City of San Antonio

Department of Development Services

Re: American Lotus Subdivision **MDP # 046-06**

American Lotus Subdivision
Master Development Plan
120.66 AC.

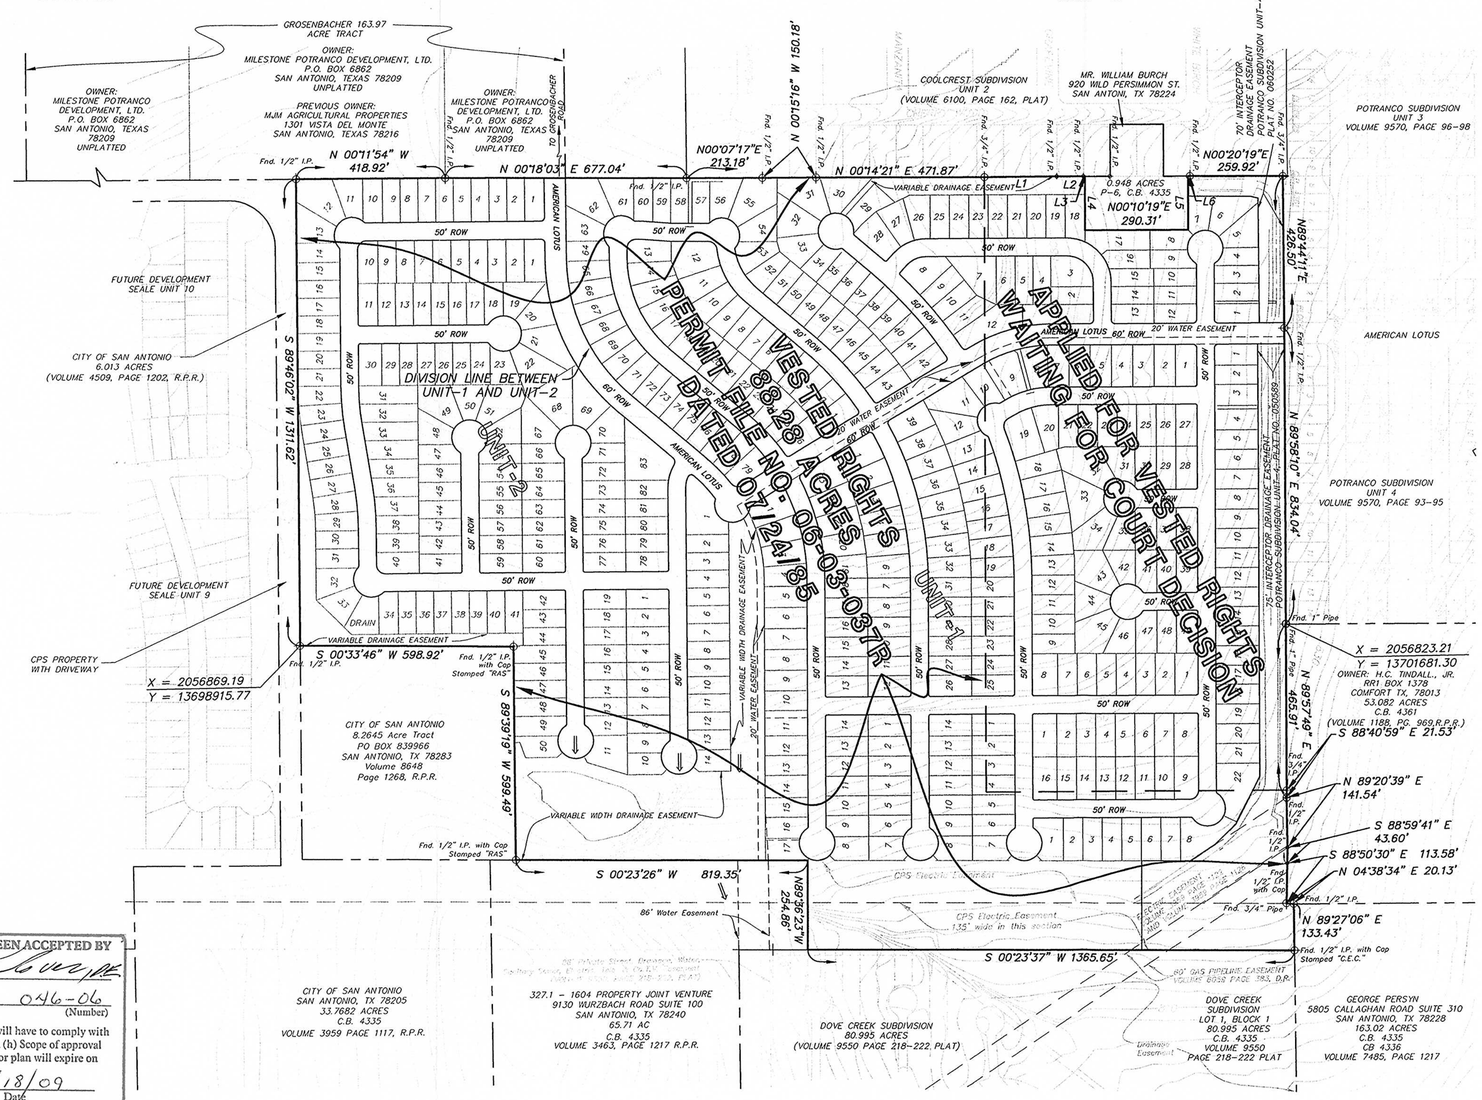
In consideration of public safety and convenience, excessive grades by reason of topography should be avoided in street layouts and arrangements.

- Secondary access must be in place prior to the approval of any plat or combination of plats that exceed more than 125 lots.

- All sidewalks shall comply with Sec. 35-506 (q) of the Unified Development Code (UDC).

- All Roadways shall conform to Table 506-2: Functional Classification System Description for Traditional Design Classification Sec. 35-506 (c) (2) of the UDC.

- Clear sight distances should be provided at each roadway intersection to allow adequate, obstruction-free viewing distances for approaching traffic. All signage, landscaping, and improvements shall be selected and located so as to not obscure the minimum intersection visibility.

- Once the number of platted lots accessing the "collector", identified as American Lotus, exceeds 800, a secondary access to American Lotus Subdivision will be required.

- The unvested portion of the project will be subject to the Tree Preservation Ordinance standards per Sec. 35-523 of the UDC. A Tree Preservation Plan is required prior to any work on lots on the site. This can be submitted either as a site work permit or at the platting stage. Additional permitting fees and affidavits will be needed to obtain tree permits. A tree permit for clearing ROW has been approved for this project under A/P 1298280.

- American Lotus is a proposed subdivision with 142 single-family residential units which are not vested. UDC Section 35-503, Table 503-1 states that single-family development is required to provide 1 acre of park/open space per every 70 dwelling units. The requirement for this development is 2.0 acres.

- The applicant has requested to pay a fee-in-lieu of providing parkland dedication. The fee must be paid prior to the recordation of the first plat associated with the unvested portion of the plan.

- The intersection of Potranco (FM 1957) and American Lotus Subdivision is expected to operate at a level of service F with the current roadway conditions as well as with improvements to FM1957 to a four lane divided roadway. Bexar County recommends the developer to work with TXDOT to analyze additional mitigation efforts.

- Secondary access shall be secured to Grosenbacher Road prior to the approval of any plat for American Lotus Subdivision.

19. ONCE THE NUMBER OF PLATTED LOTS ACCESSING THE "COLLECTOR", IDENTIFIED AS AMERICAN LOTUS, EXCEEDS 800, A SECONDARY ACCESS TO AMERICAN LOTUS SUBDIVISION WILL BE REQUIRED.

10/09/06	REVISED AS PER MDP COMMENTS
12/14/06	REMOVED DETENTION BASIN AND ADJUSTED LOTS
02/15/07	ADDED NOTE 19.
